# Access Compliance Report

## Public Rights-of-Way

Intersection ID: 14349	Main Street: REMOUNT_RD	Cross Street: TOOMEY_AV	Location: W
ADA ID: AA65E723CBF0	Ramp Type: Perp	Initial Pass/Fail: Fail	Overall Compliance: No
		Severity Score: 22.5	
Codes/Mitigation Info/Possible Solution		Field Measurements/Component Compliance

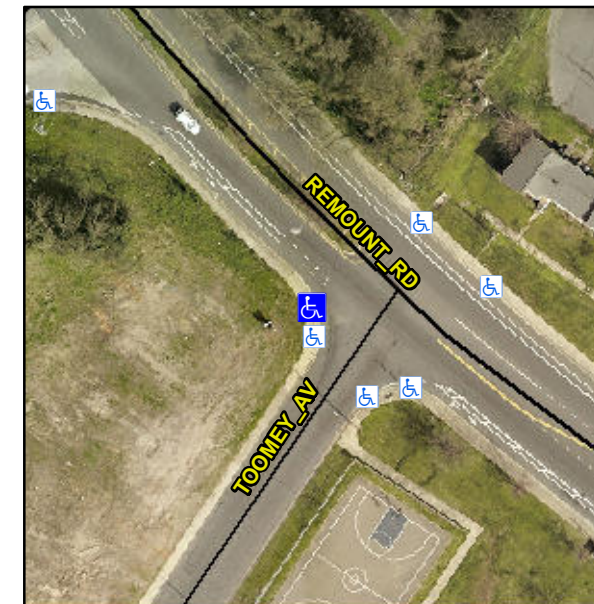
**Not Found, R304.5.1, R304.2.2, R304.5.3**

Compliance	Description	Data	Compliance	Description	Data
N/A	Ramp Length (in)	60.0	No	Ramp Slope (%)	8.5
No	Ramp Width (in)	42.0	No	Ramp XSlope (%)	4.3
N/A	Flare Type LT	N/A	N/A	Flare Type RT	N/A
N/A	Flare Slope LT (%)	N/A	N/A	Flare Slope RT (%)	N/A
N/A	Flare Traversable LT?	N/A	N/A	Flare Traversable RT?	N/A
N/A	Landing Length (in)	N/A	N/A	DWS Provided?	N/A
N/A	Landing Width (in)	N/A	N/A	DWS Contrast?	N/A
N/A	Landing Slope (%)	N/A	N/A	DWS Length (in)	N/A
N/A	Landing X Slope (%)	N/A	N/A	DWS Full Width?	N/A
N/A	Landing Curb? (Y/N)	N/A	N/A	DWS Offset (in)	N/A
N/A	Shared Landing?	N/A			
N/A	Gutter Ponding?	N/A	N/A	Gutter Slope (%)	N/A
N/A	Gutter Lip Ht (in)	N/A	N/A	Gutter X Slope (%)	N/A
N/A	Painted X Walk1?	No	N/A	Painted X Walk2?	N/A
	X Walk 1 Direction	To NE		X Walk 2 Direction	N/A
N/A	X Walk 1 Width (in)	N/A	N/A	X Walk 2 Width (in)	N/A
	X Walk 1 Slope (%)	1.0		X Walk 2 Slope (%)	N/A
	X Walk 1 X Slope (%)	3.8		X Walk 2 X Slope (%)	N/A

**Remove & Replace Entire Ramp.**
